STUDER

STUDER D820 MCH
Modifications
and
Software Update V2.2

SI 154/91 Order No. 10.85.7300 (Ed. 0791)

MP-UNIT TD CONTROL MCH 1.862.781-XX

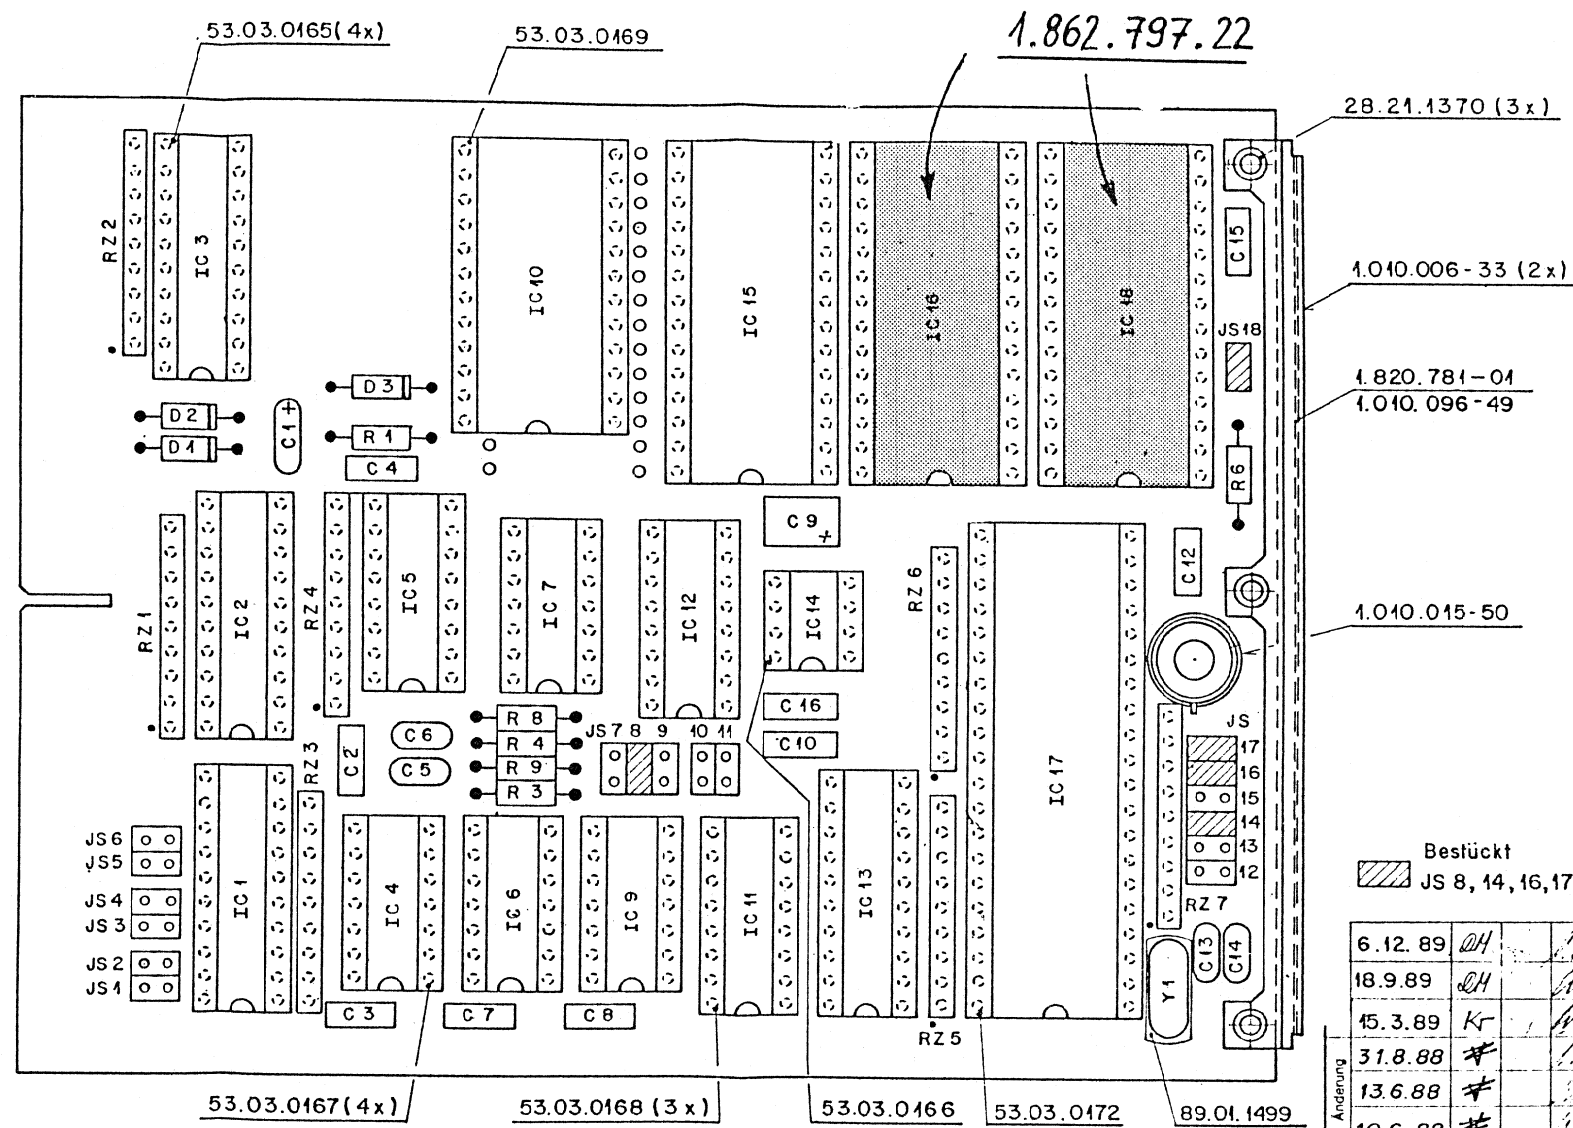
Modification MP Unit Tape Deck Control 1.862.781.21

New Master software V2.2 (28/91).

- Replace IC16 and 18 (old software number 1.862.797.21) by new software 1.862.797.22.

Change board index to new 1.862.781.22 .

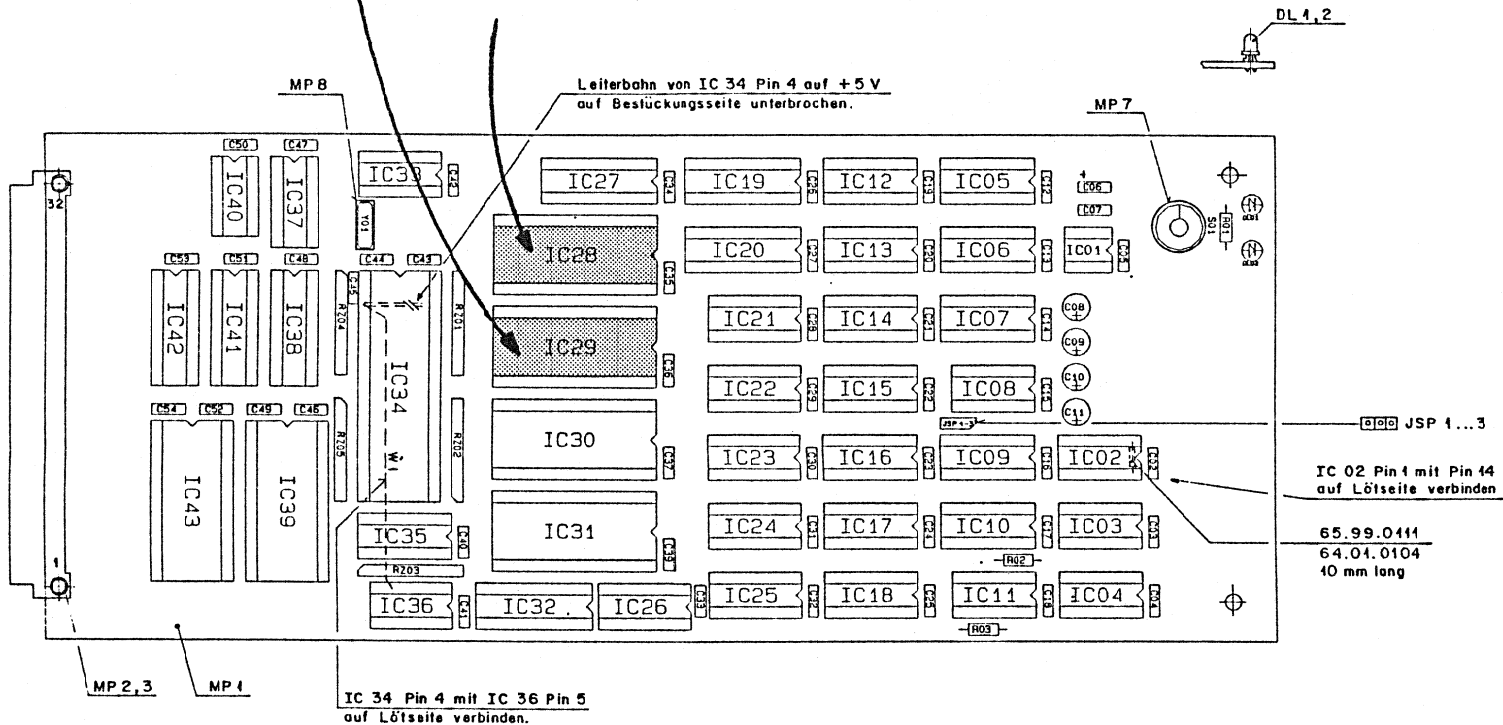
Modification Display Panel uP-Board 1.862.815.21

New Master software V2.2 (28/91).

- Replace IC28 (old software number 1.862.825.21) by new software 1.862.825.22.
- Replace IC29 (old software number 1.862.826.21) by new software 1.862.826.22.

Change board index to new 1.862.815.22 .

1.328.631.21

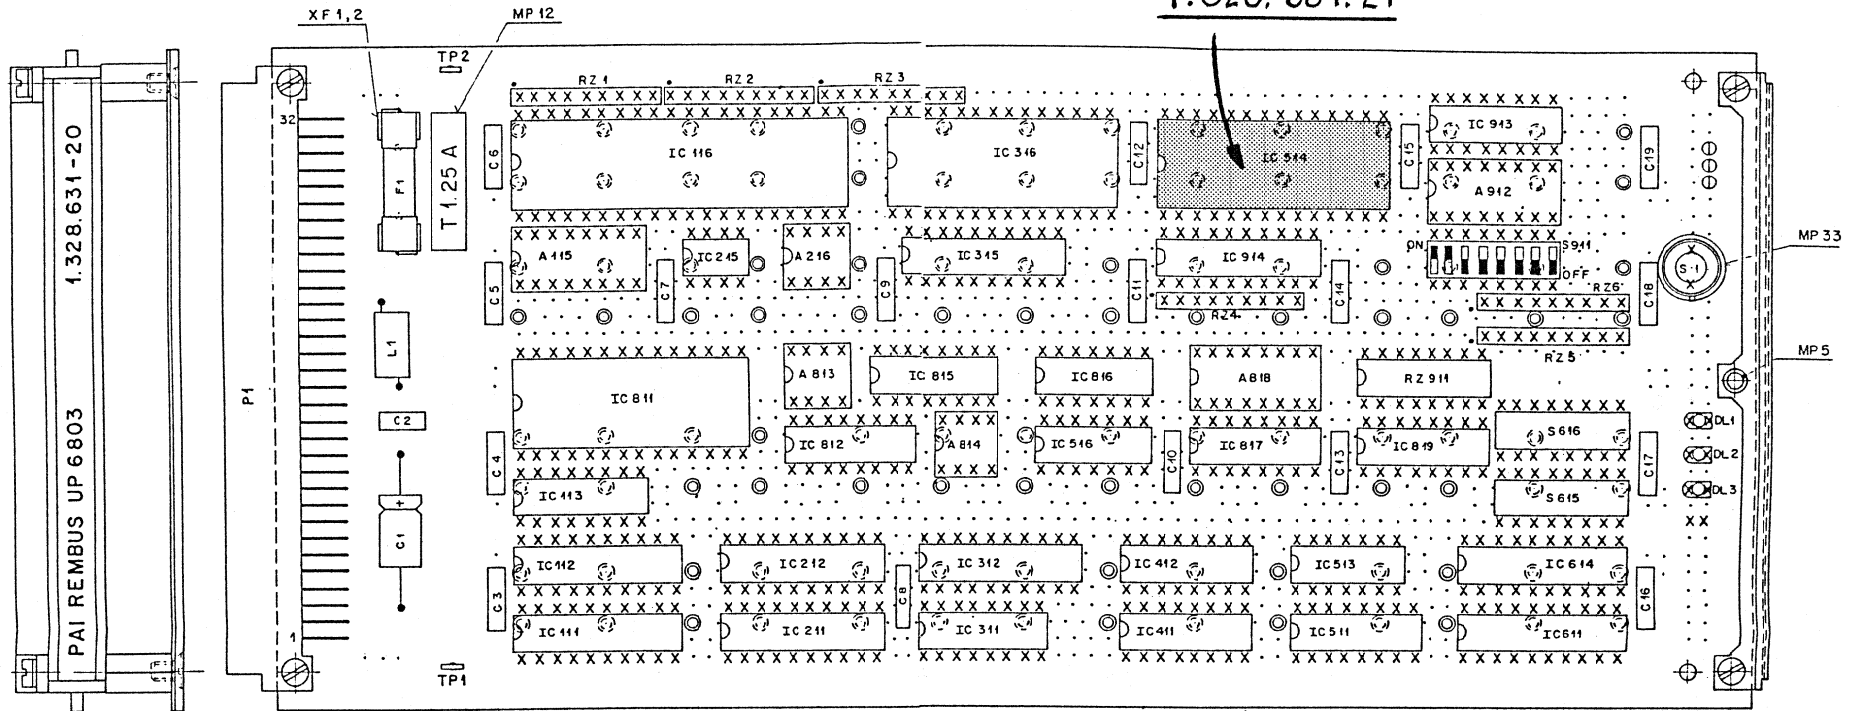
Modification PAI Rembus uP6803 1.328.631.20

New Master software V2.2 (28/91).

- Replace IC514 (old software number 1.328.896.20) by new software 1.328.896.21.

Change board index to new 1.328.631.21 .

Mark also index "21" on backside of case.

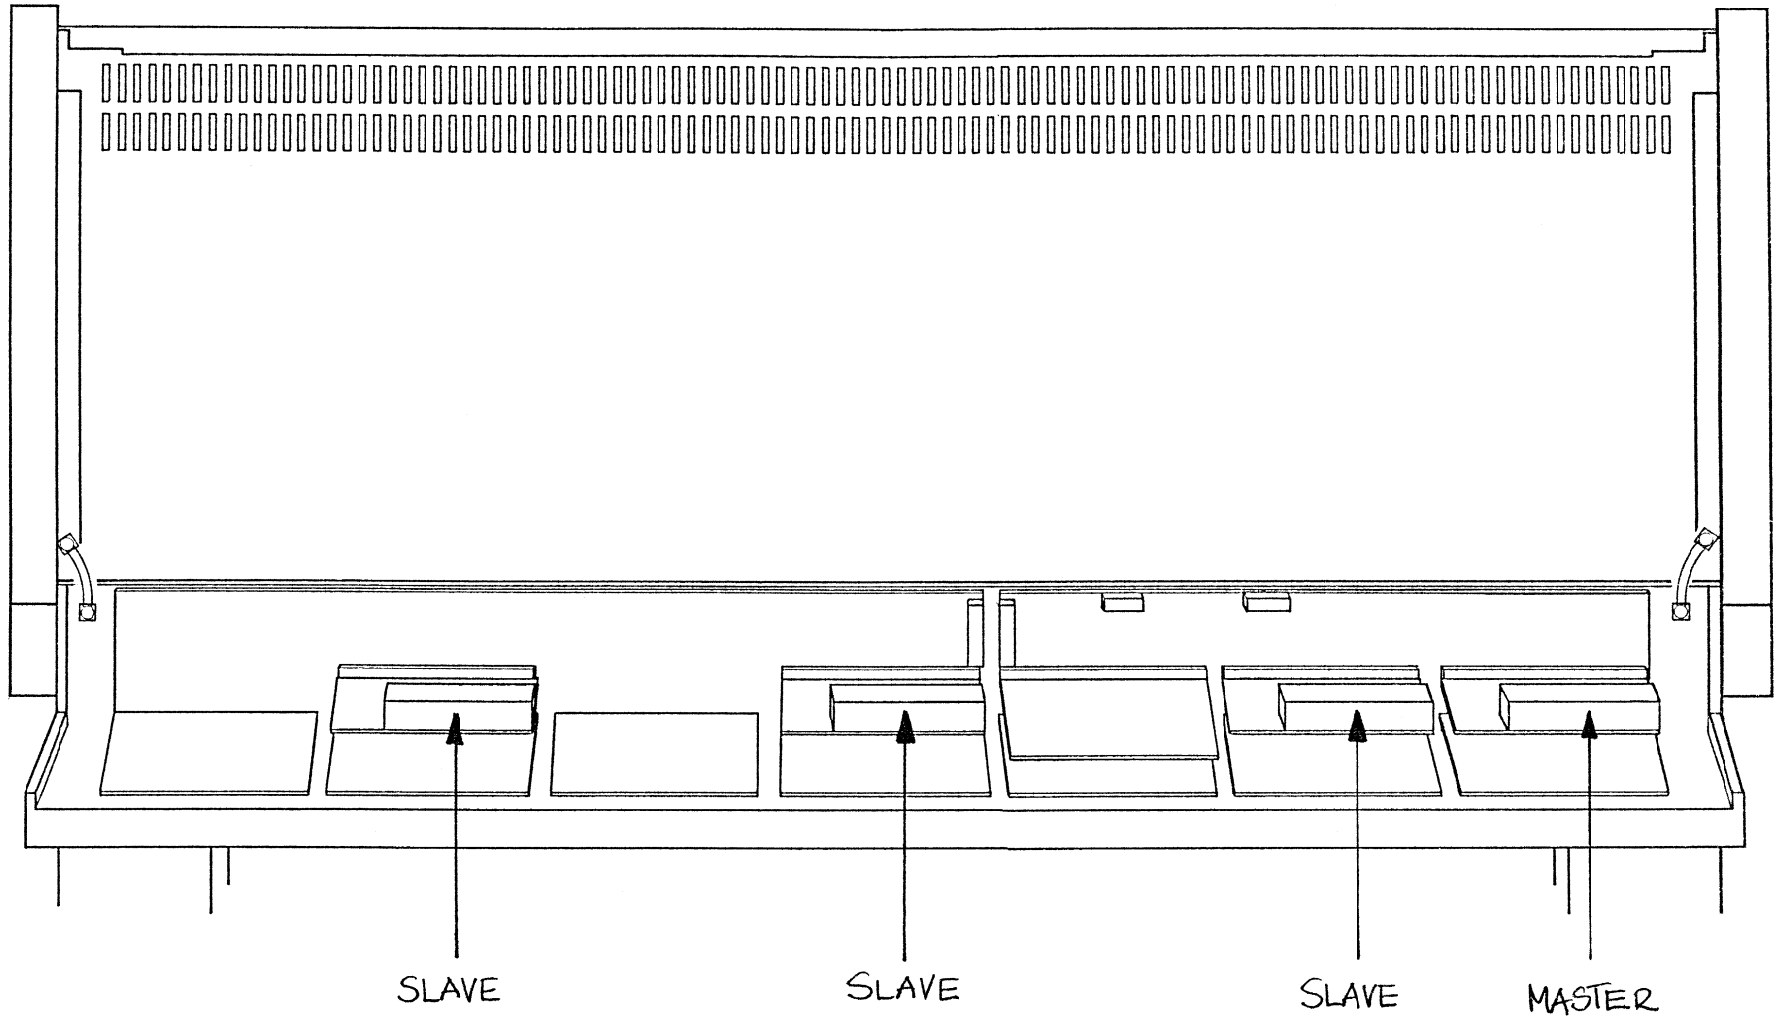
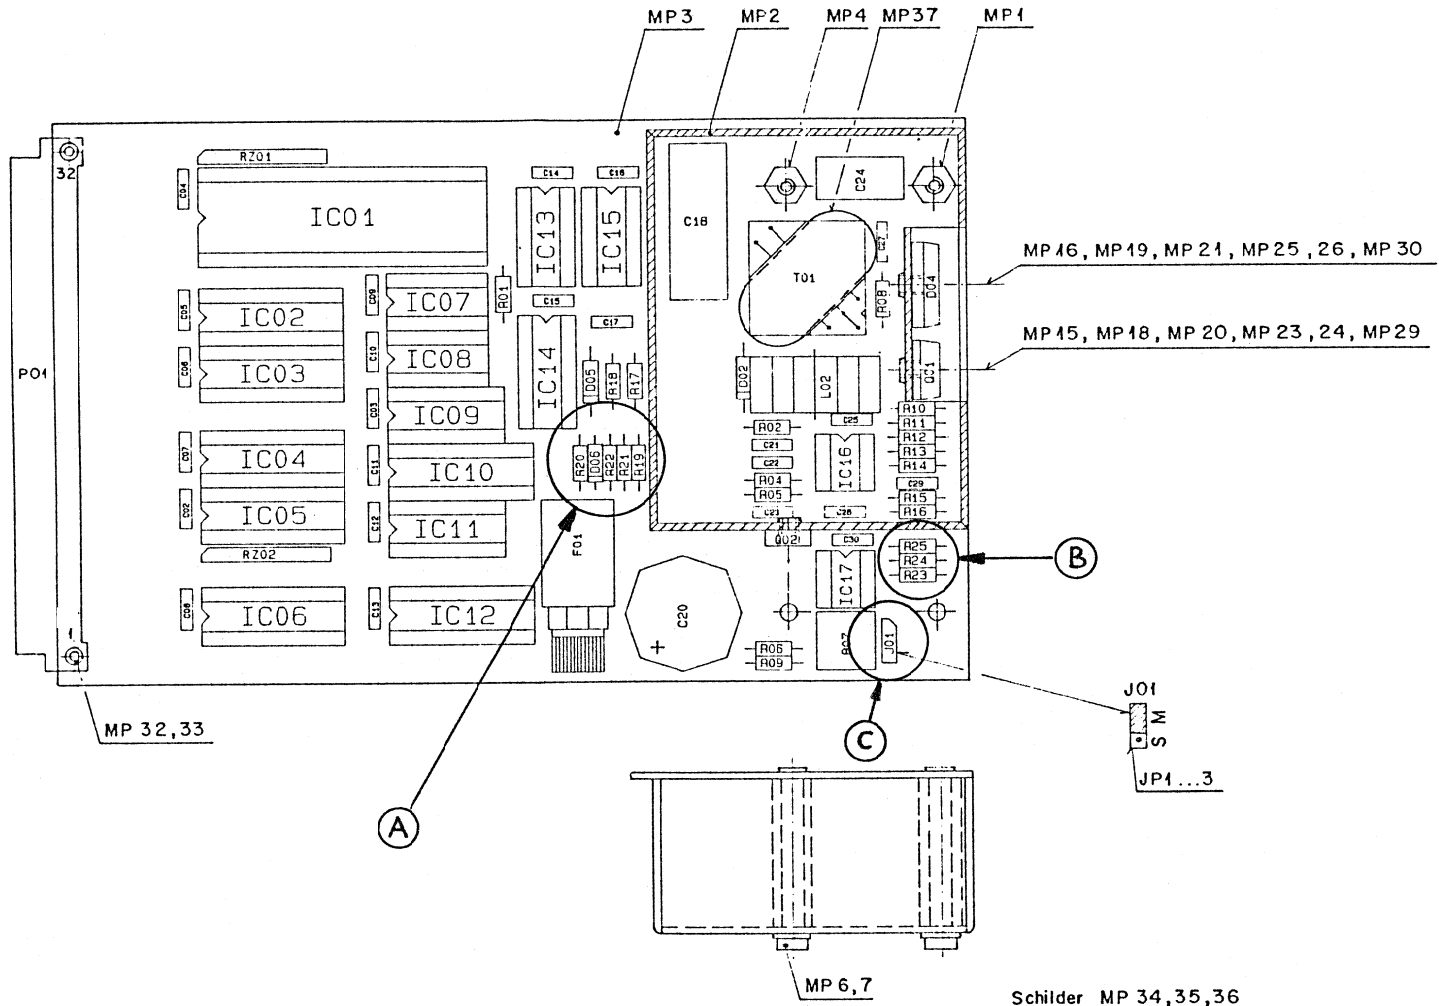
Modification Display Panel Aux Key Detection 1.862.812.00Problem:

Synchronous power-down of all four power supplies not possible.

Critical dimensioning under certain temperature conditions.

Replace R19 (47k Ohm, 57.11.3473) by 33k Ohm (57.11.3333).

Replace R20 (47k Ohm, 57.11.3473) by 10k Ohm (57.11.3103).

Replace R22 (4.2k Ohm, 57.11.3422) by 6.8k Ohm (57.11.3682).

Replace D06 (2.4 V, 50.04.1131) by 5.1 V (50.04.1112).

Remove R23 (10k Ohm, 57.11.3103).

Please check for correct Jumper setting for MASTER / SLAVE operation as indicated on the boards (refer to board arrangement).

Change board index for SLAVE-Boards to new 1.862.812.81.

Change board number for MASTER-Board to new 1.862.814.00.
